Intel[®] Mobile Pentium[®] II Processor Specification Update

Release Date: April 2000

Order Number: 243887-020

The Mobile Pentium[®] II processor may contain design defects or errors known as errata which may cause the product to deviate from published specifications. Current characterized errata are documented in this Specification Update.

New Mobile Pentium® II Processor in Mini-Cartridge Package Label with Supplier Matrix Mark Removed

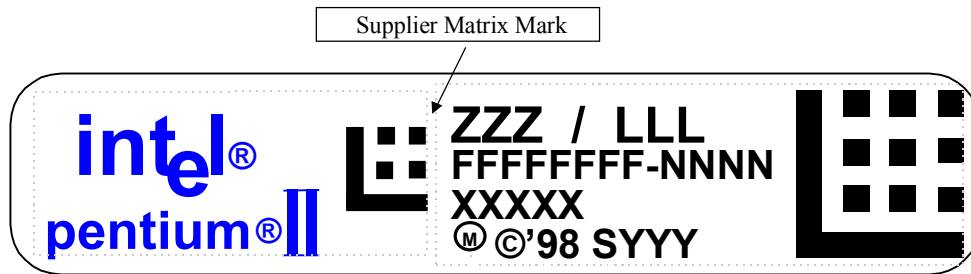
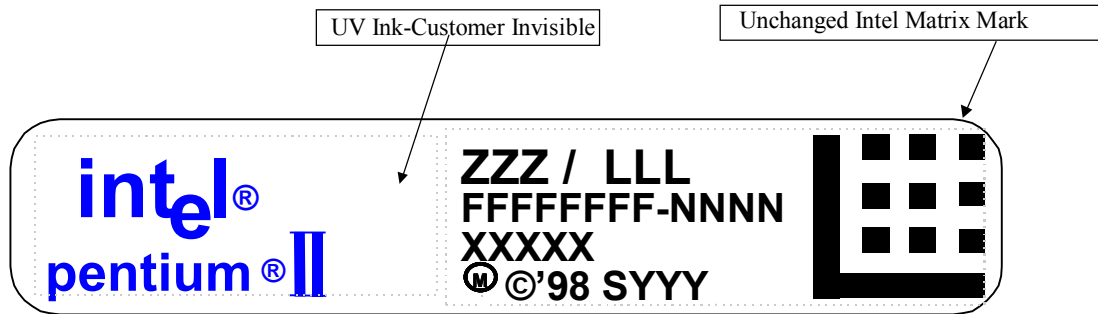
| Date of Revision | Version | Description |
|------------------|---------|---|
| April 2000 | -020 | Updated the "Pentium II Processor Mobile Module Markings" and "Pentium II Processor Mobile Module With On-die Cache Markings" sections |

Figure 5.6. Cross Sectional View with Vertical Dimensions

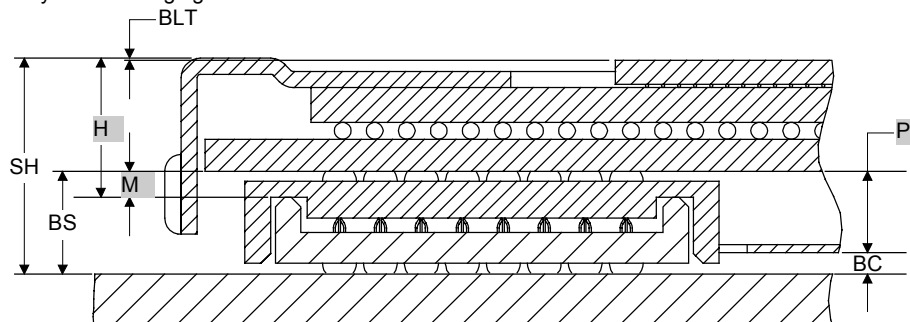
B1. Misabeled Vertical Dimension Parameters

Figure 5.6 in the *Mobile Pentium® II Processor at 233 MHz, 266 MHz, and 300 MHz* datasheet should be replaced by the following figure:

Figure 5.3. Surface-Mount BGA1 Package—Top and Side View

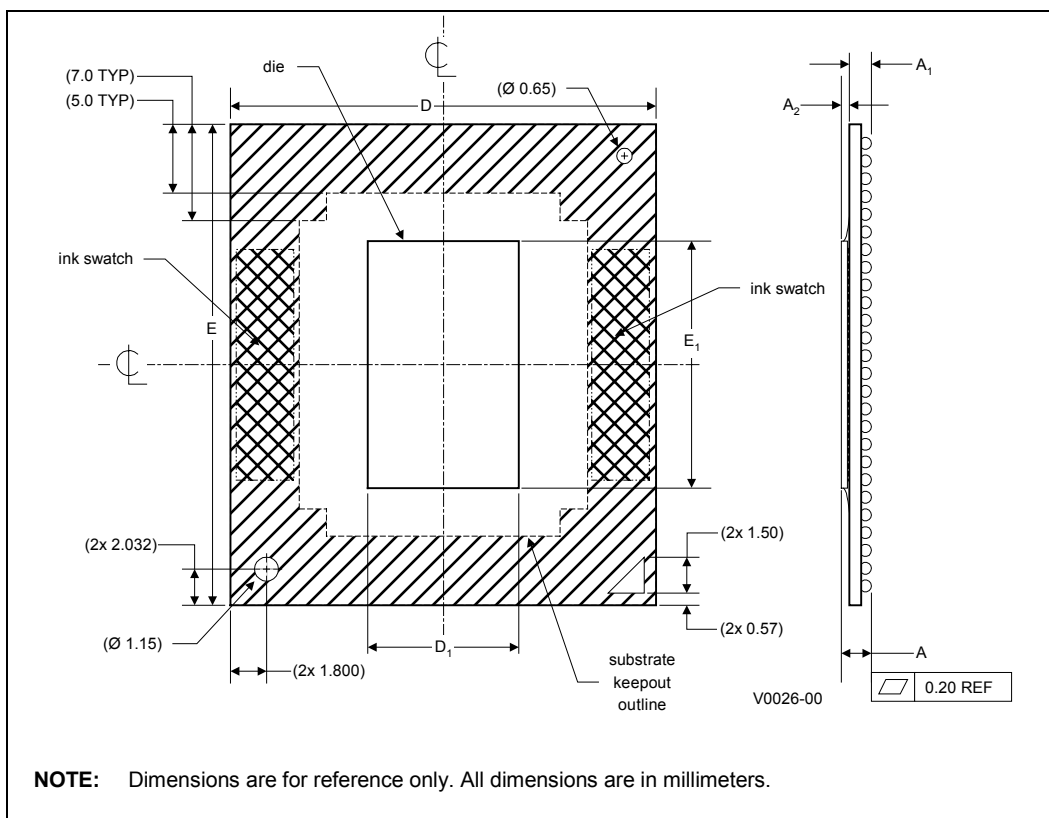
The following table and figures show the updated mechanical specifications for the BGA1 package, listed as Table 5.2, Figure 5.3 and Figure 5.4, respectively, in the *Mobile Pentium® II Processor in BGA Package at 366 MHz, 333 MHz, 300PE MHz, and 266PE MHz* datasheet.

Figure 3.3 Generic Clock Waveform

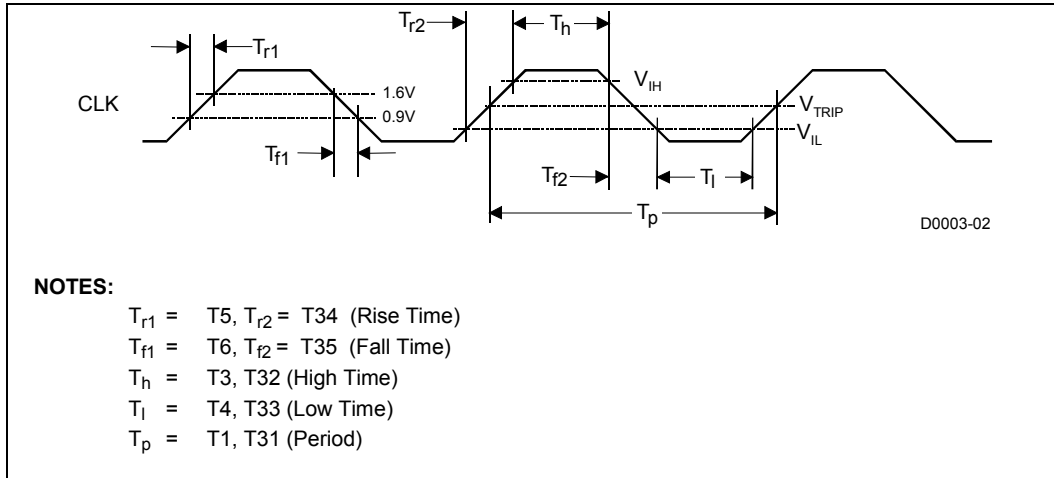
B14. Generic Clock Waveform Figure

Figure 3.3 in *Mobile Pentium® II Processor in Mini-Cartridge Package at 366 MHz, 333 MHz, 300PE MHz, and 266PE MHz* datasheet (Order Number 245108), and the *Mobile Pentium® II Processor in BGA Package at 366 MHz, 333 MHz, 300PE MHz, and 266PE MHz* datasheet (Order Number 245106) has been updated. The following figure is to replace the ones in the above documents.

Figure 1. TAP Gageable Thread Clarification

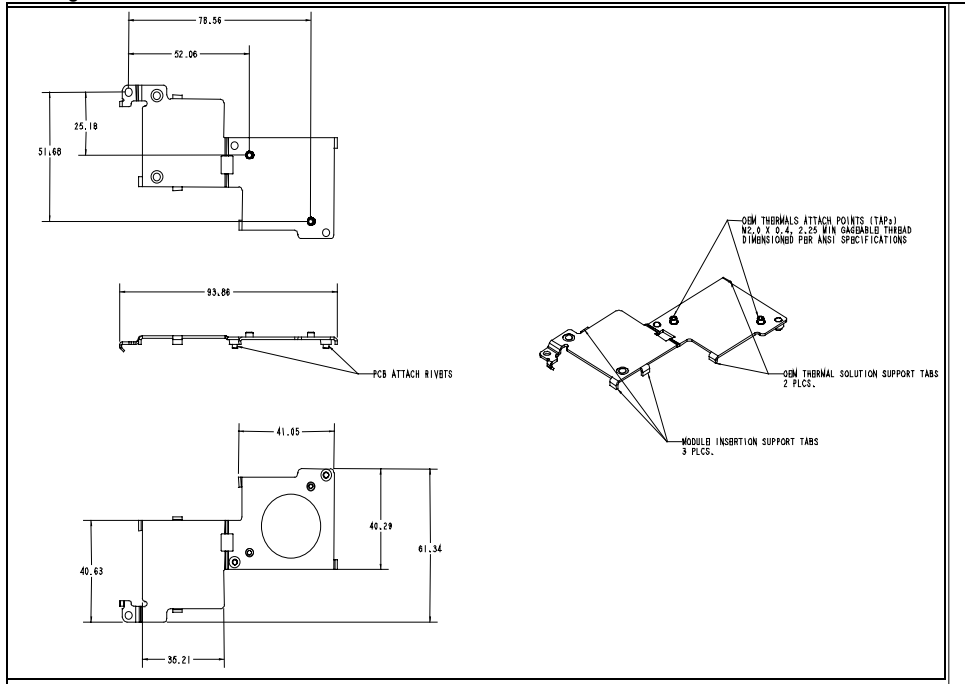
In the *Intel® Pentium® II Processor Mobile Module : Mobile Module Connector 1 (MMC-1)* and the *Intel® Pentium® II Processor Mobile Module : Mobile Module Connector 2 (MMC-2)* datasheets (Order Numbers 243667 and 243668, respectively), the thermal attach point (TAP) gageable thread specification was not clearly identified in Figure 14, of Section 5.2. The following is the TAP clarification:

OEM Thermal Attach Points (TAPs) M2.0 x 0.4, 2.25 min gageable thread dimensioned per ANSI specification.

See Figure 1 below for more information.
